File: DP 15-697654

Re: **Application by Canada Haotian Investment Ltd. for a Development Permit at
8191 Alexandra Road**

Excerpt from the Minutes from
The Design Panel Meeting

PROJECT
8191 ALEXANDRA ROAD
 RICHMOND, BC
DRAWING TITLE
SITE PLAN
DRAWING NO.
PLAN #1A
 DP 15-697654

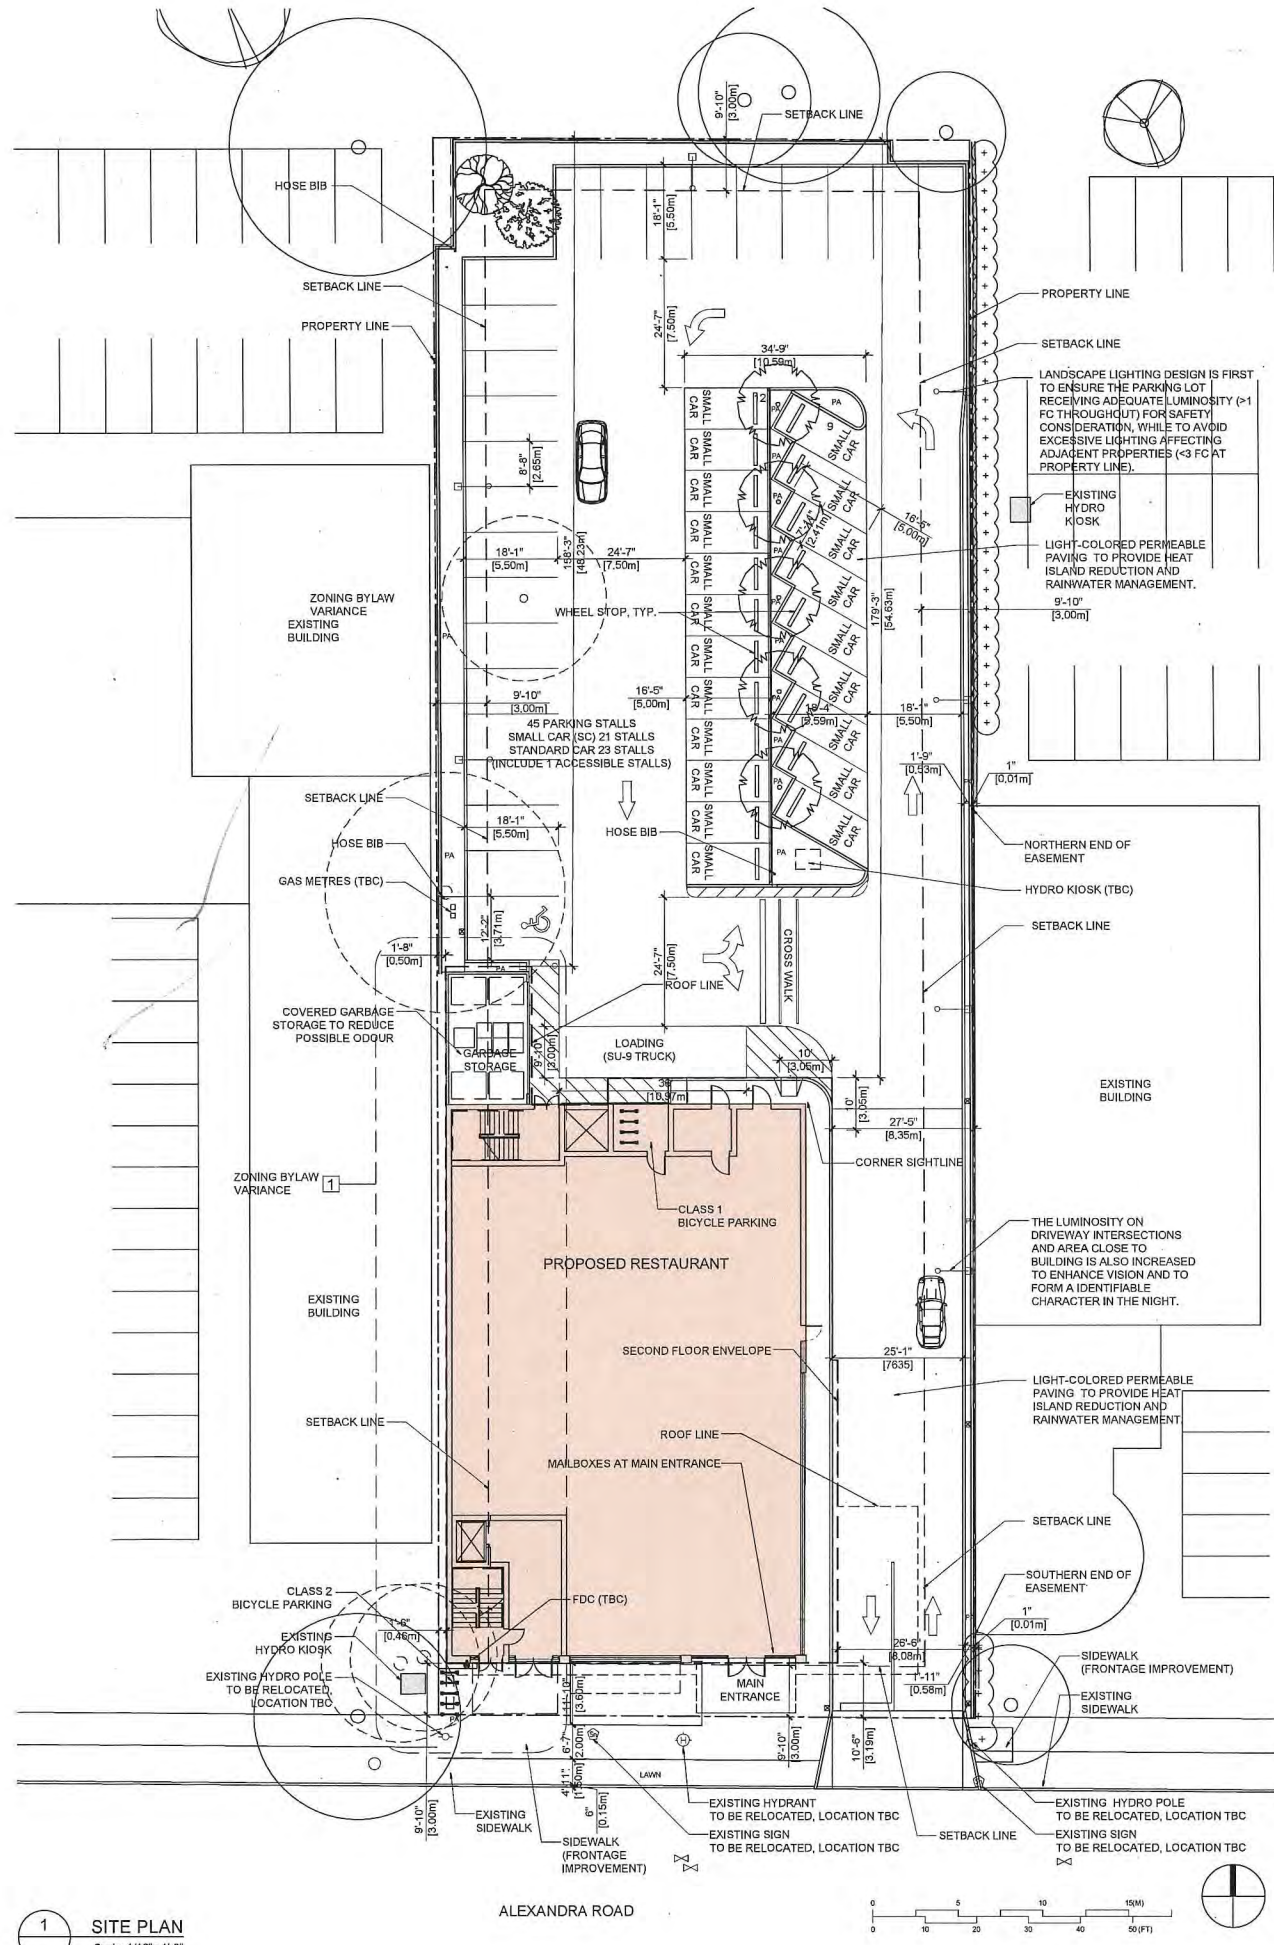
ZONING BYLAW VARIANCE

| NO. | BYLAW | DESC | REQUIRED | PROPOSED |
|-----|----------|----------------|----------|-------------|
| 1 | 10.3.6.2 | MIN. SIDE YARD | 3.0M | 0.5M @ WEST |

1 LANDSCAPE SITE PLAN
Scale: 1/16" = 1'-0"

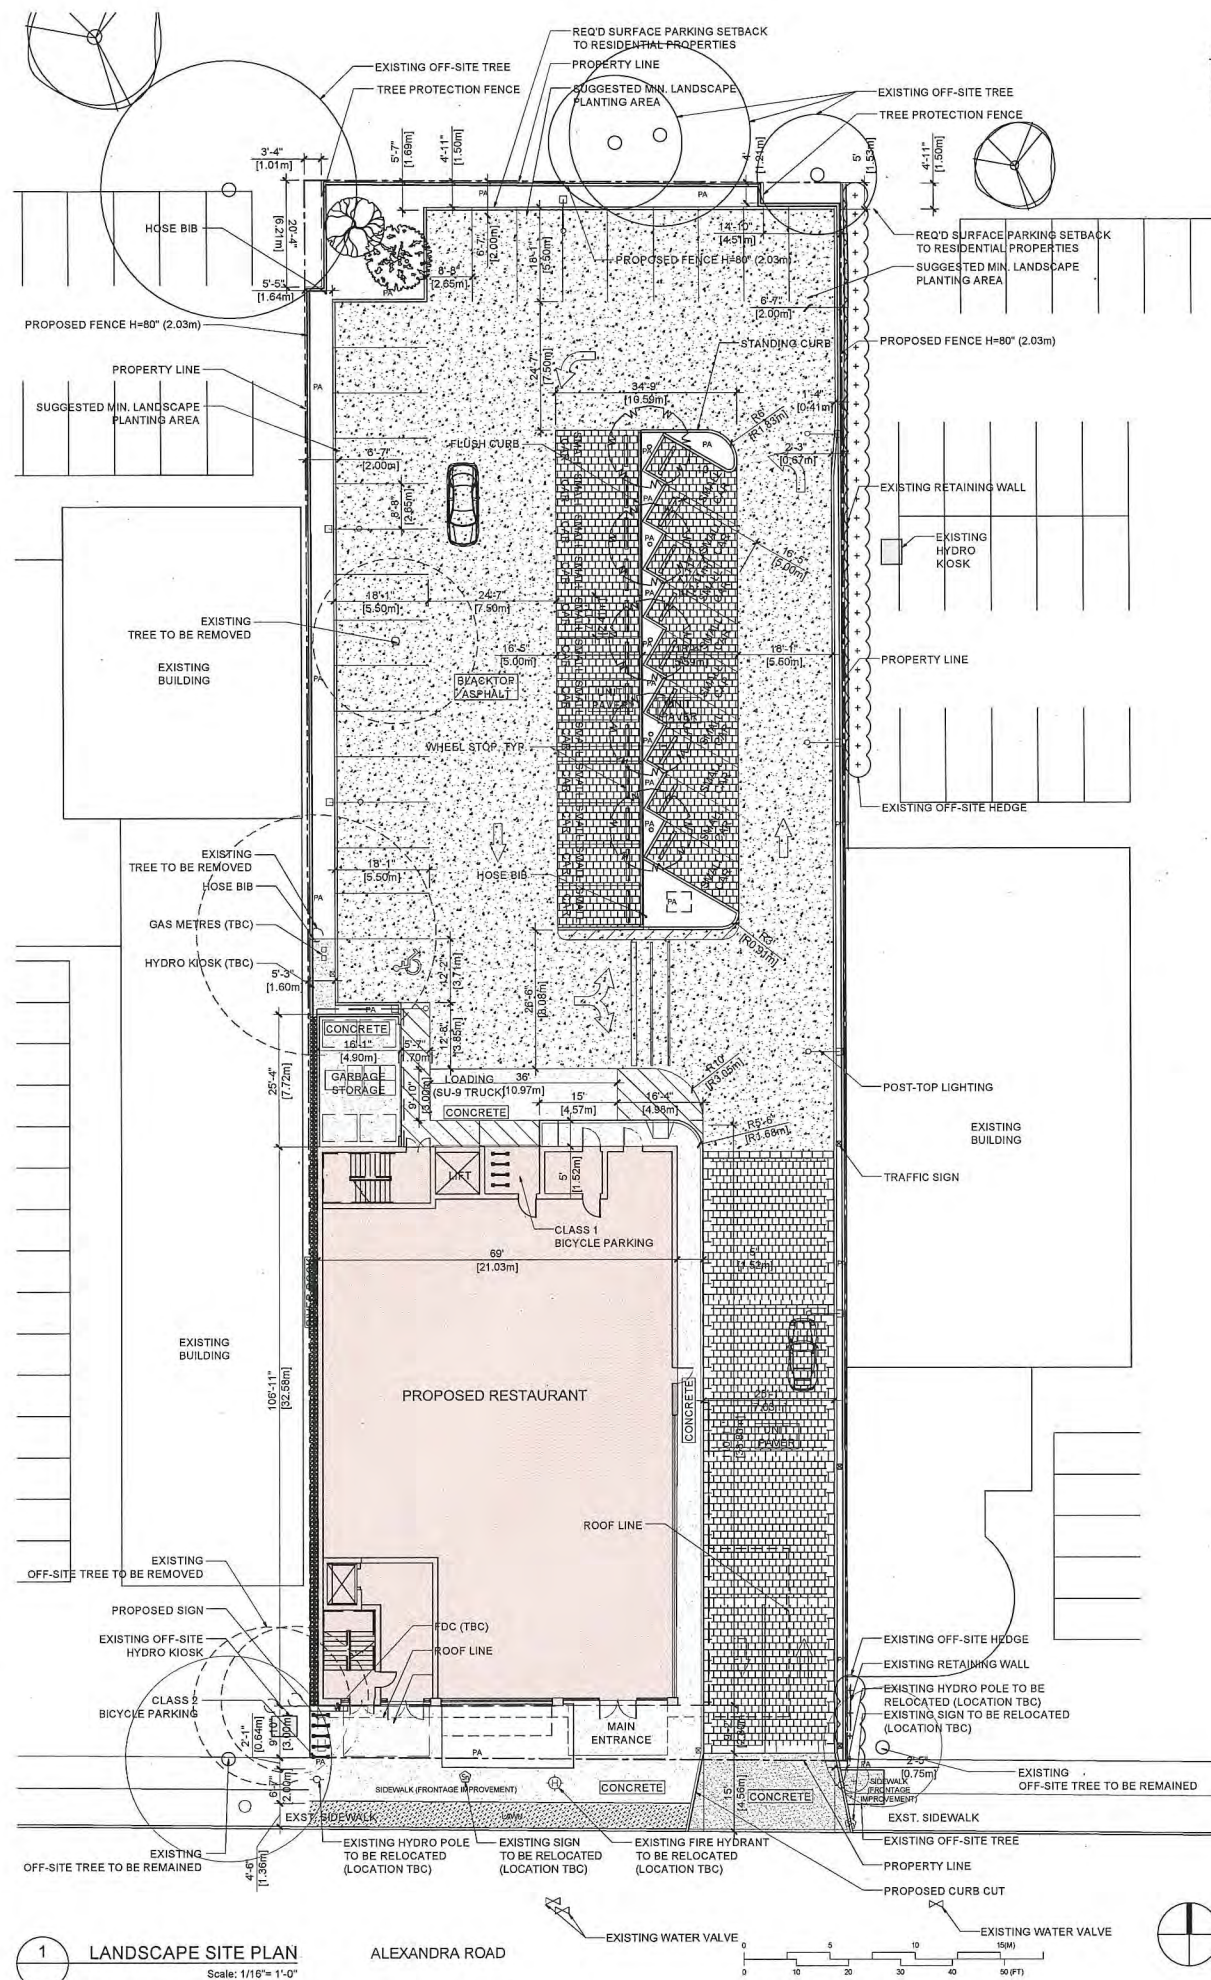
- landscape plan looks good; however, there are too many trees planted in the northwest corner; consider retaining only either grand fir or western red cedar trees;
Acknowledged, the grand fir has been removed and the western red cedar and pacific dogwood to be retained.

- consider introducing some patterning to the large permeable unit paver paving at the entrance driveway; and
Acknowledged. The stripe pattern has been added on entrance driveway. see landscape plan.

DRAWING TITLE: **LANDSCAPE PLANTING PLAN**

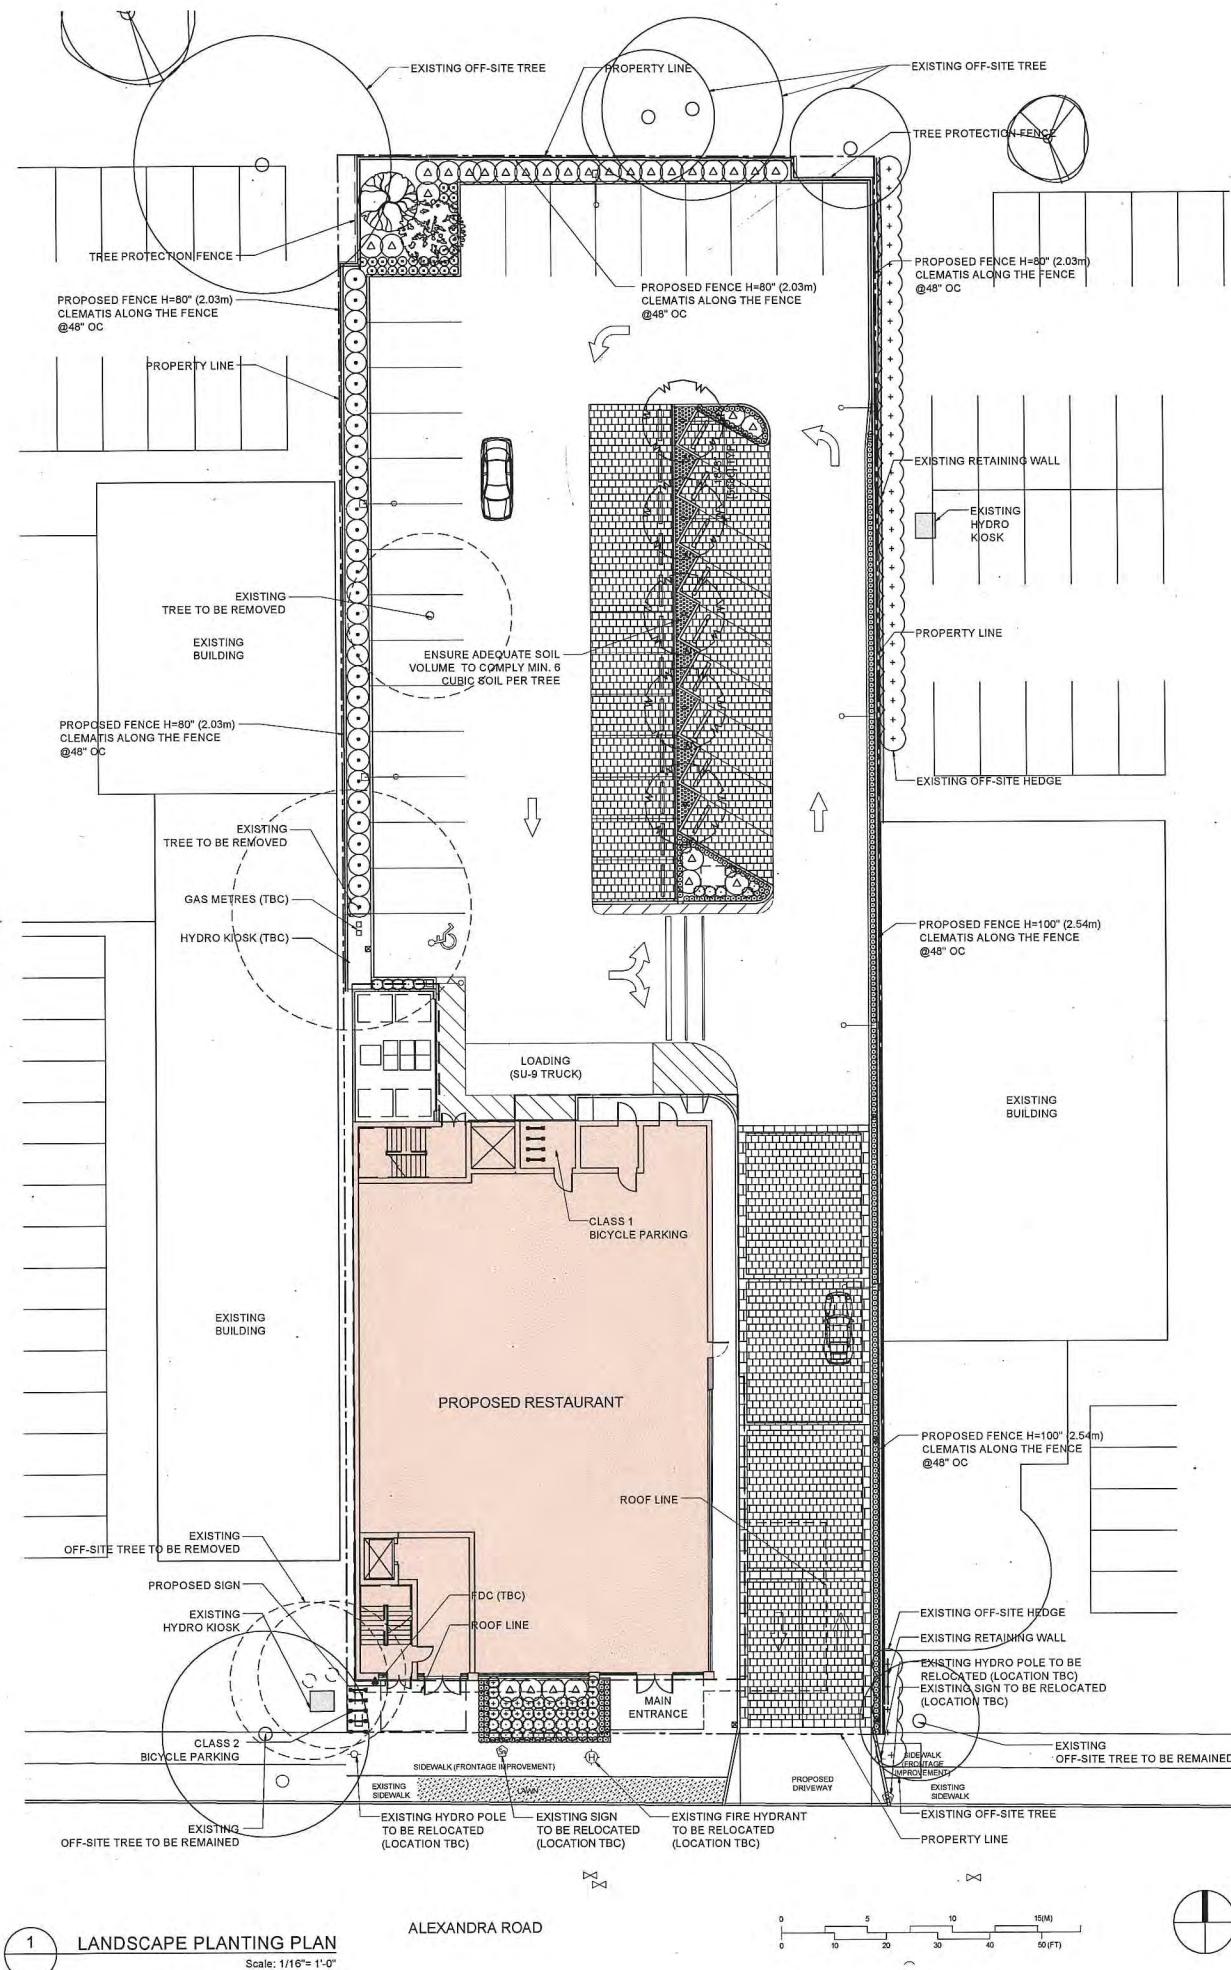
- consider replacing the western sword fern in the planter at the front of the building with another species more appropriate for full southern sun exposure;
Acknowledged, the western sword fern has been replaced by Choisya Ternata, which is appropriate for full southern sun exposure. See landscape plan.

- concerned on the health of red maples in the median at the outdoor parking area; consider introducing wheel stops to protect the trees from vehicles; also ensure adequate soil volume for the red maples;
Acknowledged, the wheel stops will be introduced to protect the trees from vehicles. The adequate soil volume will be ensured in construction drawing phase to comply min. 6 cubic soil per tree. See landscape plan.

- ensure adequate soil volume for the red maple trees in the parking area; spacing between trees appears too close; applicant needs to demonstrate compliance with applicable regulations; structural soil might be required; curb stops would be necessary to keep vehicles off the tree trunks;
Acknowledged, the wheel stops will be introduced to protect the trees from vehicles. The adequate soil volume will be ensured in construction drawing phase to comply min. 6 cubic soils per tree. See landscape plan. The typical spacing between trees is 18'-8" (5.6m).

- proposed vine planting at the east side of the subject site could grow vigorously and present a potential issue with the adjacent development; consider a free standing trellis/green screen product and an appropriate type of vines;
The free standing trellis has been added along the east side of the entrance driveway. The proposed vine planting has been changed to Clematis the president, which is better flowering looking less aggressive. See landscape plan.
